**Re: Grand River Dam Authority, FERC Project No. 1494-438;
Response Comments on Sedimentation Study and Submission of
Updated Study Plan for Approval**

GRDA Response Comments on Sedimentation Study Plan

Appendix A: Comment Response Matrix

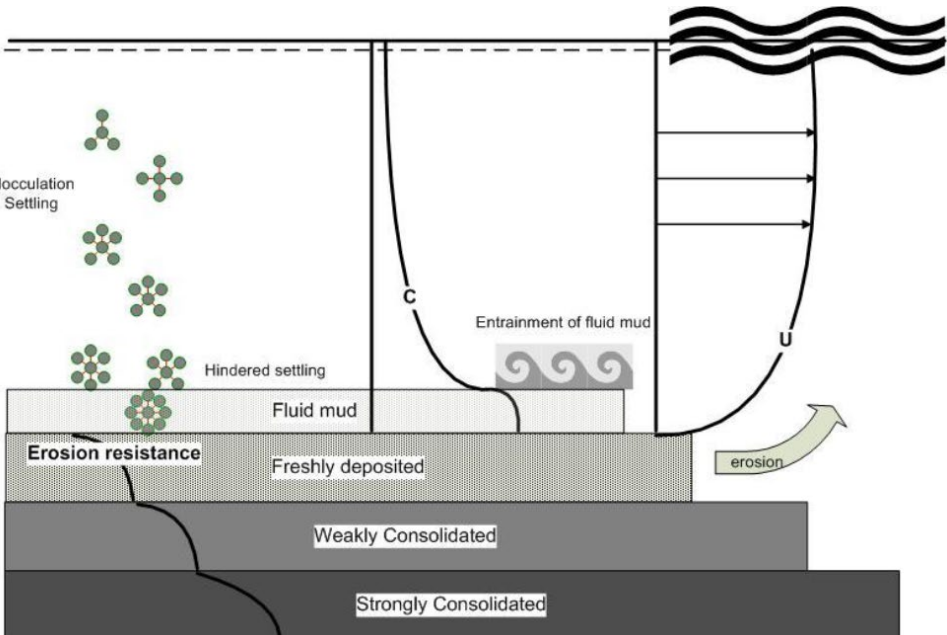
Comment No.	Section	Page No. Paragraph	Tetra Tech Observation	GRDA Response
				<p>The following figure from “The Methods of Coastal Models” Modelling of Cohesive Sediment Dynamics by Ulrik Lumborg and Hans Jacob Vested (2008) shows the various stages and characteristics of sediment as it deposits on the bed of the reservoir.</p>  <p>Suspended sediment forms flocs that deposit at the bed. With increasing currents, the loose mud layer is re-entrained. Bed shear stresses can be enhanced by short surface waves and during spring tides or storms the lower sediment layers are eroded. From Lumborg and Vested (2008).</p> <p>They explain the various stages and characteristics of suspended sediment deposition as follows: <i>Fluid mud / hyper concentrated suspensions: The concentration of suspended sediment in the water column increases towards the bed. When the flocs begin to touch each other and interact hydrodynamically the settling velocity is reduced. This phenomenon is known as hindered settling and may lead to high concentration suspensions or fluid mud layers. Fluid mud is a concentration of fine-grained material in which settling is substantially hindered. It forms when the rate of settling exceeds the capacity of dewatering. The process forms a very concentrated suspension that acts neither as a Newtonian fluid nor as a sediment bed. The lower concentration limit of naturally occurring fluid mud layers is often given as about 10 kg m⁻³. This concentration can often be recognized as a lutocline and it is around this concentration that the suspension transits to become framework supported and much less mobile than the suspension. Fluid mud layers are thus layers with extreme concentrations of sediment. The layer is moveable but moves as a gel rather than as a Newtonian fluid. Fluid mud layers accomplish a significant challenge for fine-grained sediment modelling.</i></p> <p>When the box core samples were collected for the SEDflume testing, those collecting the samples observed the following (Integral Consulting 2020): “In general, sediment consisted of silt and clay with a surface layer of</p>

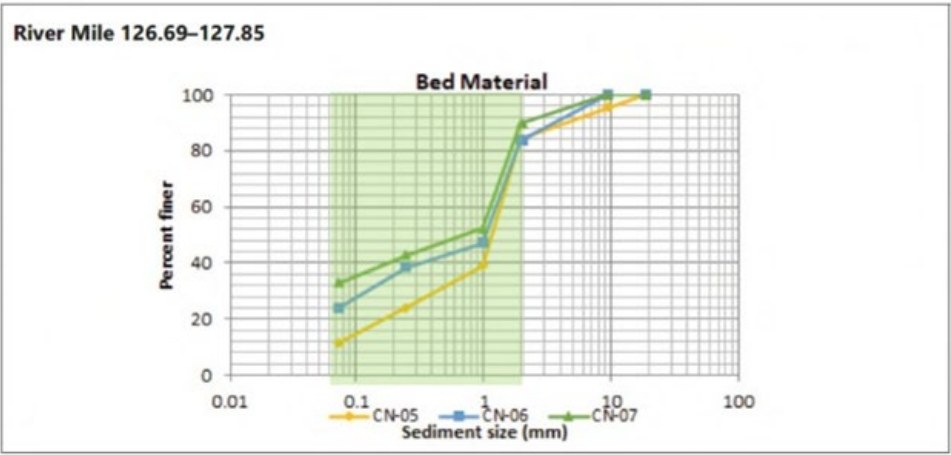
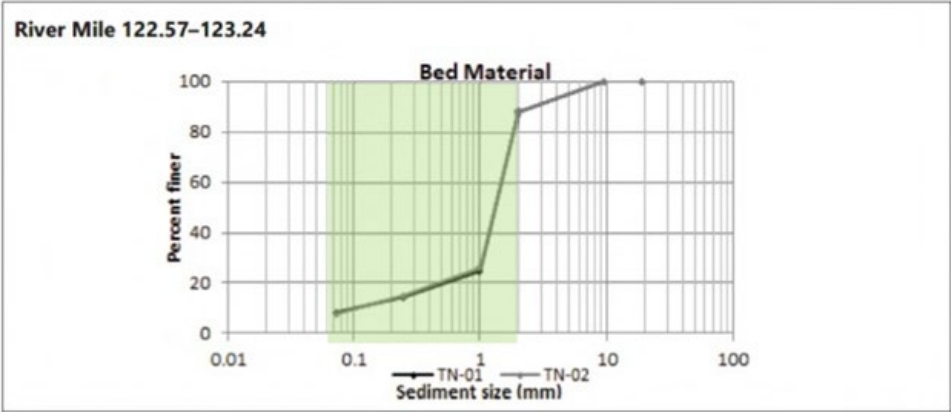
Comment No.	Section	Page No. Paragraph	Tetra Tech Observation	GRDA Response
51		6, 3	<p>The figures below are taken straight from the December Sedimentation Report; they show GRDA's grab sample data, with each curve representing the proportions of different sediment sizes in an individual sample. To each, the City has added a green box spanning the range of sediment sizes considered to be sand (including by GRDA). The percentage of sand in a sample is the difference in the curve's height from one side of that box to the other. For example, in the first graph below, subtracting the values on the left side of the box from the values on the right side shows that sand makes up roughly 55% (sample CN-07) to 70% (sample CN-05) of the samples.</p> <p>The sample data show that sand dominates the Neosho River bed starting about four to six miles above Twin Bridges and the start of the hump.</p>  <p>This holds true moving downstream, as 11 of the remaining 13 grab samples from lower in the Neosho River contain about 50% to 80% sand. Those samples span Twin Bridges, the peak of the hump, and several miles below (roughly corresponding to the following three graphs):</p> 	<p>Samples CN-05 through CN-07 were collected at RM 126.69 to 127.85. These locations are approximately 4 to 5 miles upstream of the upper end of the delta feature. The non-cohesive material upstream of the delta feature is typical of the non-cohesive sediment found in the riverine reaches upstream. These samples do not represent the finer sediment forming the delta feature.</p> <p>On the delta feature, cohesive silts and clays form a significant portion of the sediment (see GRDA's Response Comment, Section 3.3 and Appendix C) which decrease the suitability of the cohesive sediment transport routines used by HEC-RAS. Regardless, after considering comments received from the City and others following the January 2022 Technical Meeting, GRDA has re-evaluated the data and has proposed a USP that relies on HEC-RAS modeling of sediment transport at and above the Elk River confluence. This compromise allows GRDA to explicitly model the upper portions of the study area (including the critical reach containing the delta feature) and separately evaluate those portions where the limited cohesive sediment capabilities of HEC-RAS are unable to accurately simulate the complex system. In addition to sediment transport modeling the USP includes qualitative geomorphic and quantitative engineering and geomorphic analyses as part of the three-level approach.</p> <p>Please see GRDA's response to Comments No. 36 and 49.</p>

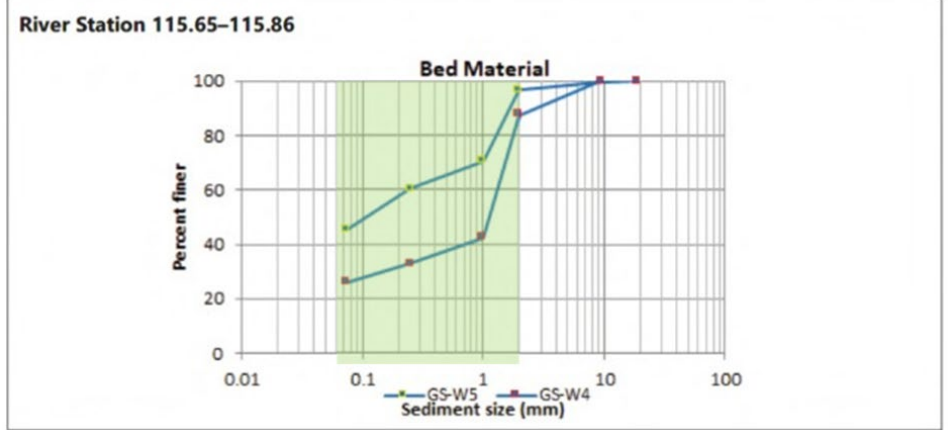
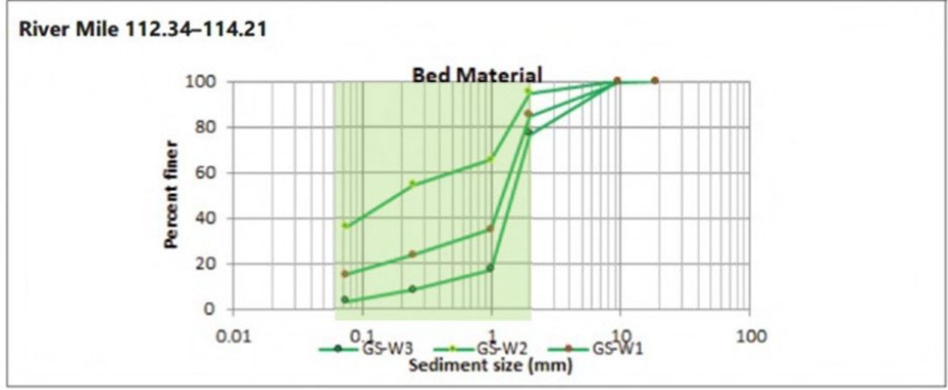
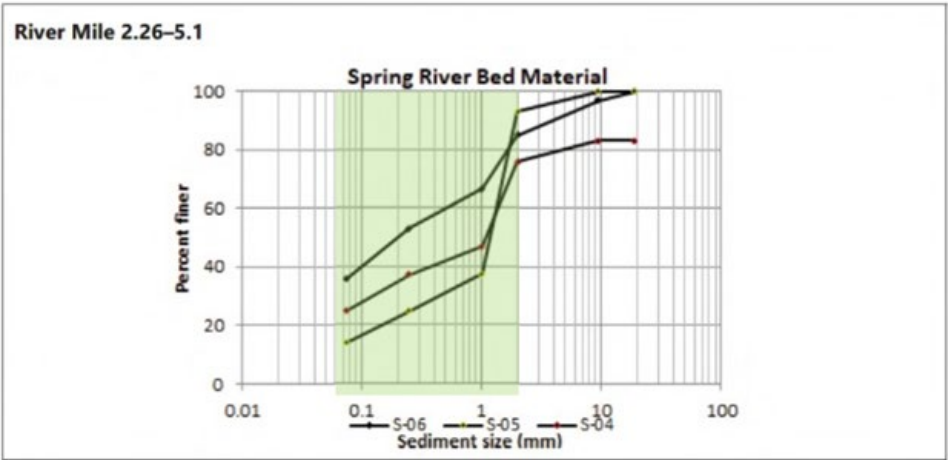
Comment No.	Section	Page No. Paragraph	Tetra Tech Observation	GRDA Response
			<p>River Station 115.65–115.86</p>  <p>River Mile 112.34–114.21</p> 	
52		9, 1	<p>The Spring River tells a similar story. Sand dominates all four grab samples in the five miles just above the confluence with the Neosho, near the upstream end of the hump:</p> 	<p>The City is again asserting that the sediment in the delta feature region is primarily non-cohesive, but as discussed in GRDA's Response Comment, Section 3.3 and in their response to Comment No. 49, much of the sediment in that location is cohesive.</p> <p>Regarding the full scope of the study, FERC's SPD required GRDA to evaluate the impacts of sedimentation on the power pool and storage volume as well. The limited parameterizations used by HEC-RAS for cohesive sediment transport are not capable of accurately simulating cohesive deposition in the lower reaches of the reservoir. GRDA's USP proposes a compromise solution that would rely on explicit modeling in upstream areas and a separate analysis in the lower reservoir to address this issue. Please see GRDA's responses to Comments No. 3 and 6.</p>

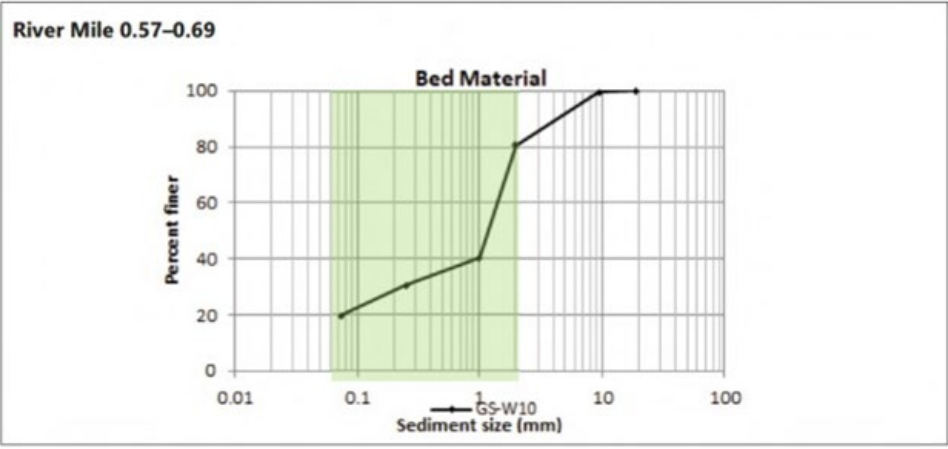
Comment No.	Section	Page No. Paragraph	Tetra Tech Observation	GRDA Response
			<p align="center">River Mile 0.57-0.69</p>  <p>These results show remarkable agreement that non-cohesive sands dominate the bed for 15 critical miles where the tributaries meet the reservoir. Deep in its report, GRDA acknowledges this: “The profile of the riverbed shows a distinct hump where the primary non- cohesive sediment deposits are located in the reservoir[.]” GRDA’s data (presented above) show that sand dominates those deposits, so GRDA’s statement about the hump appears irreconcilable with another statement in the same report: “The results showed limited volumes of sand in either stream or lake sediments with most of the lakebed being finer than sand and most of the riverbed being coarser than sand[.]” Because that latter factual representation is the linchpin to GRDA’s entire argument against HEC-RAS, the graphs above lay that argument to rest.</p>

Figure 2. Comparison of water surface elevations at RS 122.75 from STM and UHM for the October 2009 event

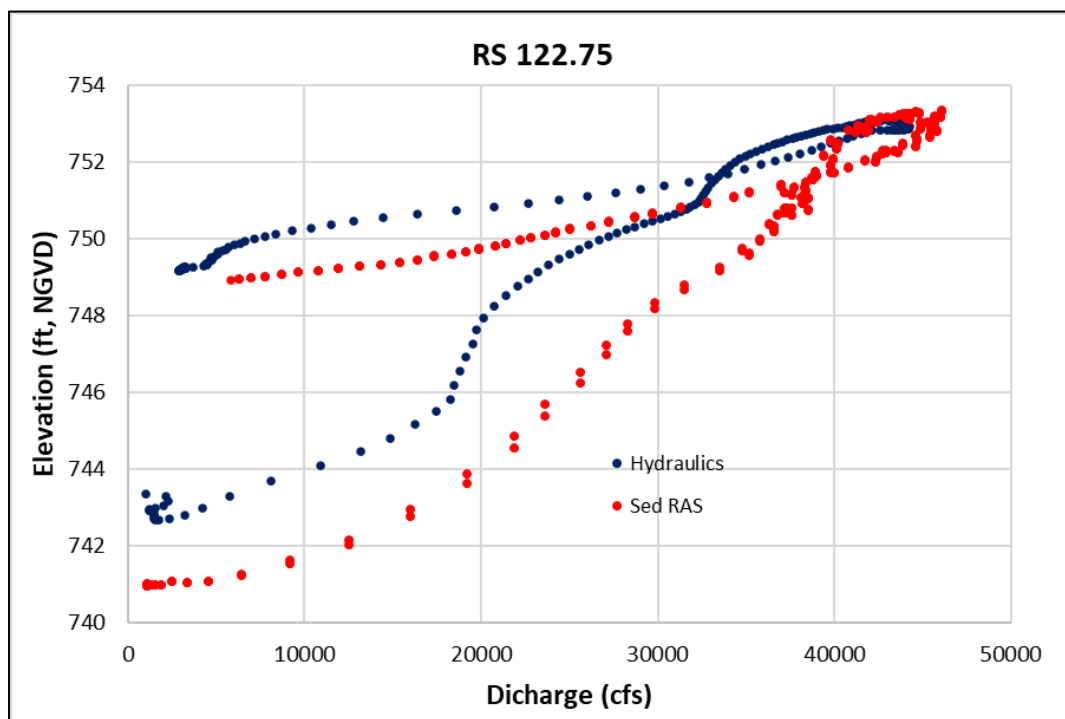
(1) **Hydraulic Calibration.** The hydraulic calibration may have been completed using the geometry file based on the 1998 terrain data; the 1998 terrain data is the current geometry associated with the plans for the fixed bed calibration events (April 2017, January 2017, December 2015, October 2009, July 2007, and May 2019) mentioned in the ISSR. However, there are two steady-state model runs (Calibration-2009 and Calibration-2019) with the appropriate geometry files that could have been used for hydraulic calibration. Unfortunately, no information related to hydraulic calibration was provided. Therefore, the hydraulic calibration should be revisited for the new base geometry condition used for the model calibration if the same events documented in the ISSR are being considered. Otherwise, the next sedimentation report should document the hydraulic calibration efforts of the STM. Special attention should also be given to differences related to the model results from the hydraulic analysis. This could be important near bridges. Figure 2 compares the water surface elevation at RS 122.75 (just upstream of Hwy 60 bridge at the Twin Bridges State Park) calculated using the STM and UHM for the October 2009 event. This figure shows that there are noticeable differences in the water surface elevations computed between the two models.

Figure 4. Elevation versus storage volume relationship for Grand Lake reservoir

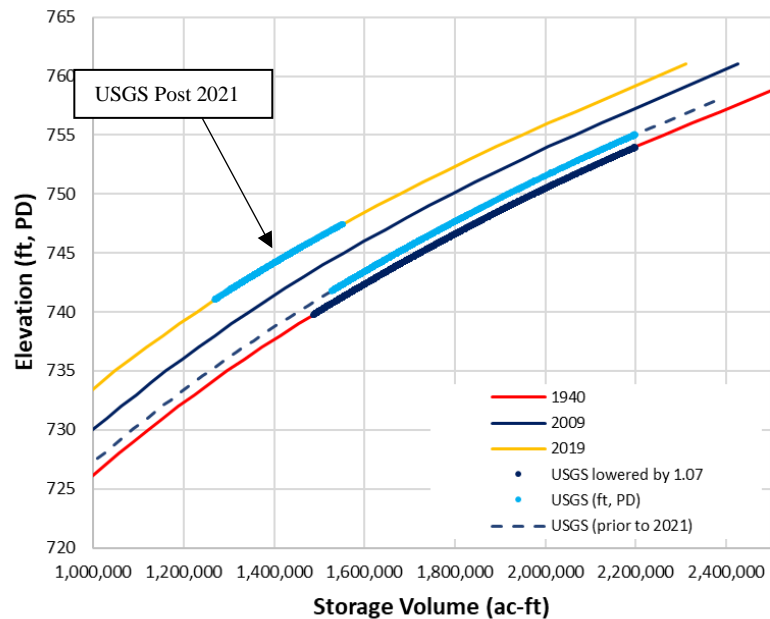
(5) **Downstream Boundary.** There is a potential discrepancy at the downstream boundary (Figure 4). Figure 4 shows the 1940, 2009, and 2019 storage capacity curves. It also shows the storage capacity (light blue markers) curve developed using data obtained from the USGS website. The USGS data after January 1, 2021, matches the 2019 relationship, while the data prior to 2021 matches the relationship that is 1.07 ft above the 2019 relationship. The USGS website indicates that these data are referenced to the PD datum. The Pensacola reservoir backwater study (USACE, 1941) indicates that the USGS changed benchmark elevations, and the maps used for their analysis are from an old base line that is 1.072 ft lower than the corrected base line. It appears the USGS has not applied this adjustment to the data on their website, and the reported elevations are referenced to the NGVD and not PD datum. If correct, then the downstream water surface elevations in the model are consistent with the geometry data. If not, then the downstream water surface elevations would have to be adjusted.

Figure 5. Observed versus HEC-RAS simulated weight of sediment deposition

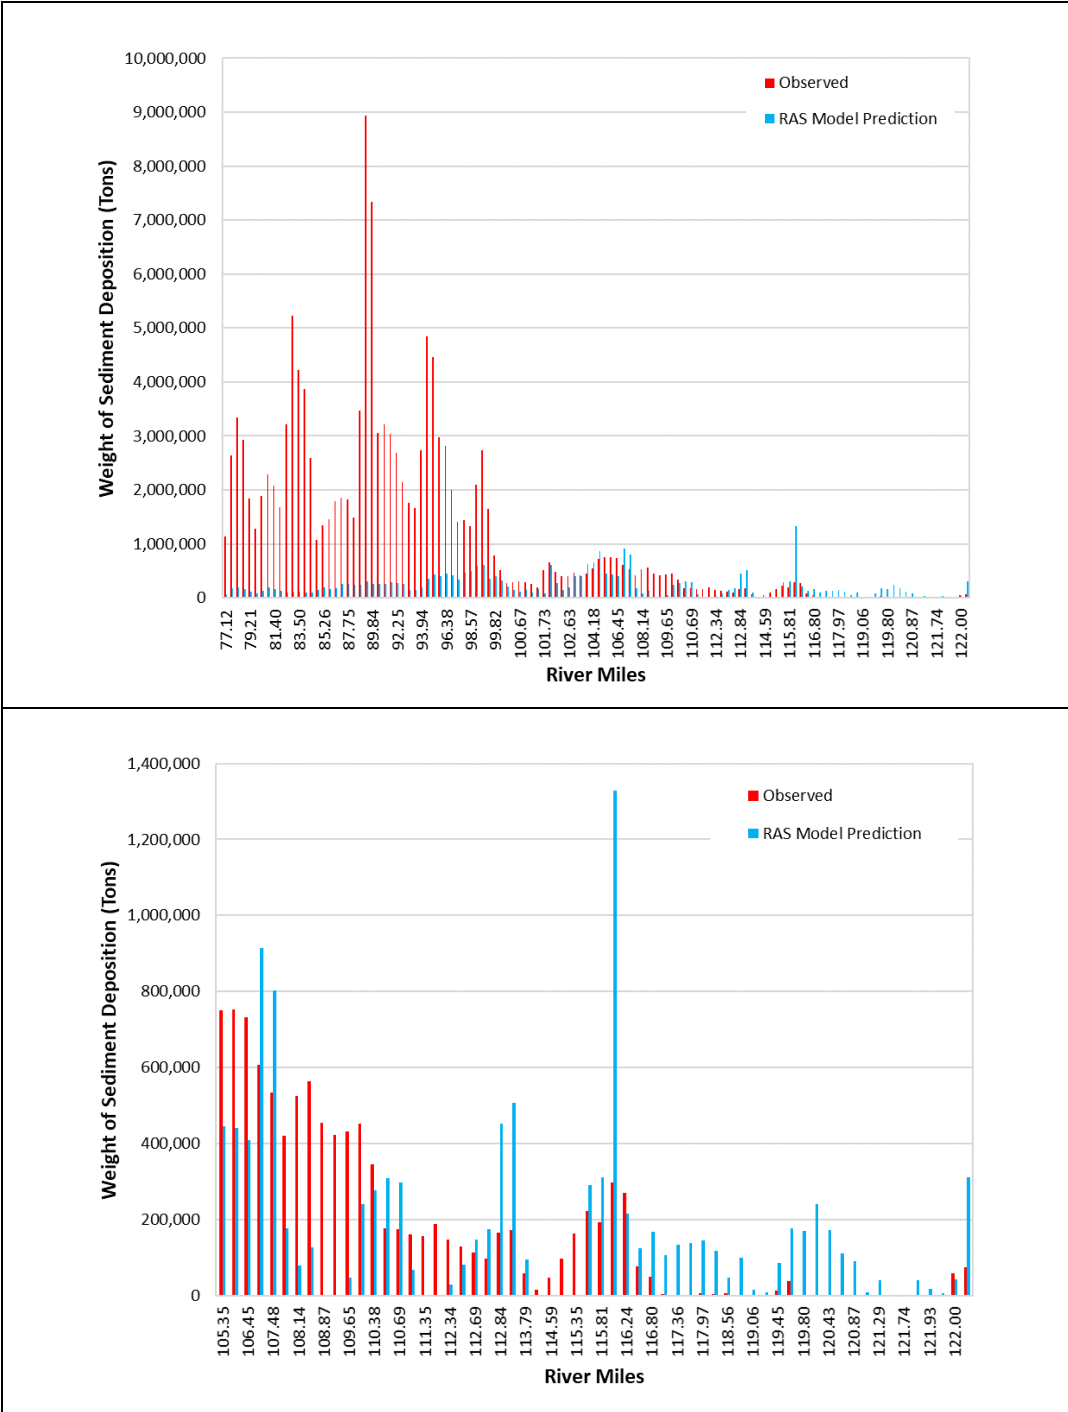
(6) **Sediment Transport Calibration Results.** The model results were evaluated in terms of the weight of sediment deposition within the reservoir downstream of where Spring River flows into the Neosho River. Figure 5 shows the simulated weight of deposition from the STM compared to the measured weight of deposition. The results indicate that the model: (1) underpredicts the weight of depositions below RM 105.25, and (2) has a similar amount of weight sediment depositions within the reach between RM 105.25 and RM 122.25, but it does not accurately simulate the spatial distribution within the reach.

Figure 8. Comparison of 1941 USACE and 1998 REAS

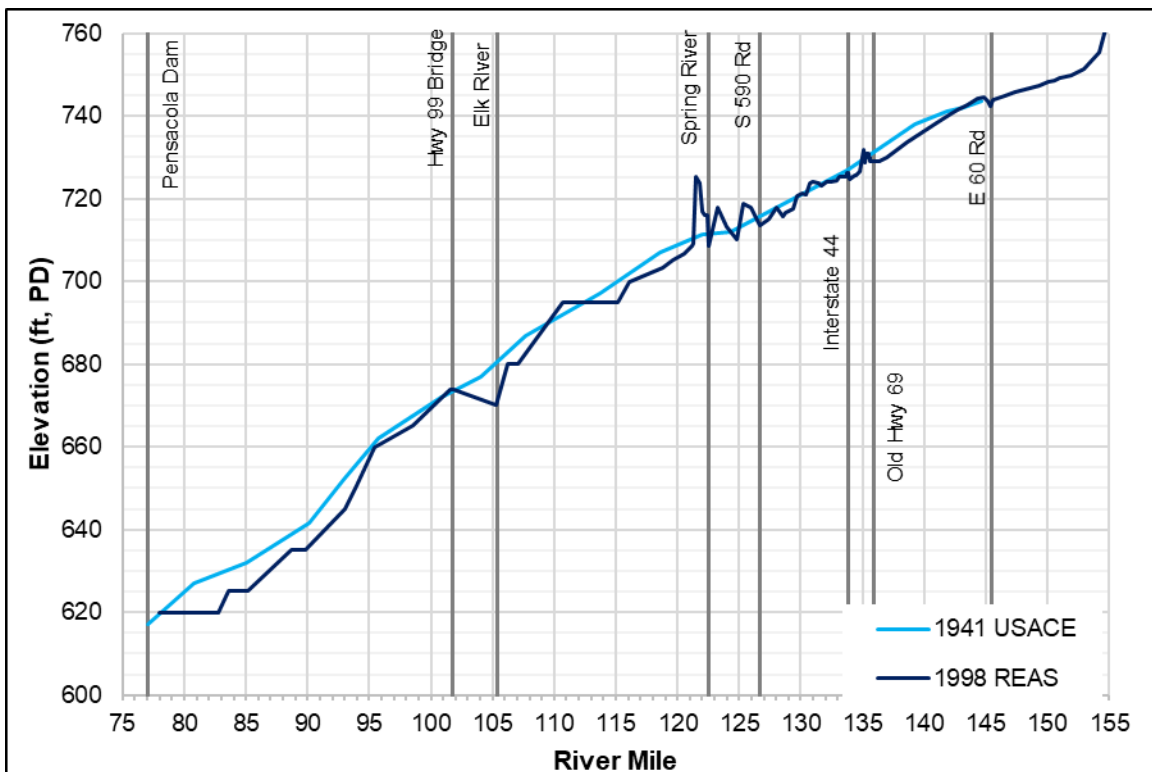
It was mentioned during the initial meeting that there were some concerns related to the 1998 REAS profile reflected in the historic thalweg comparison plot. Figure 8 shows the comparison plot of the 1940 and 1998 REAS thalweg profiles. This plot shows that, in many locations, the 1998 REAS thalweg profile is at a lower elevation than the 1940 thalweg profile, which is extremely unlikely due to the backwater influences from Pensacola Dam.
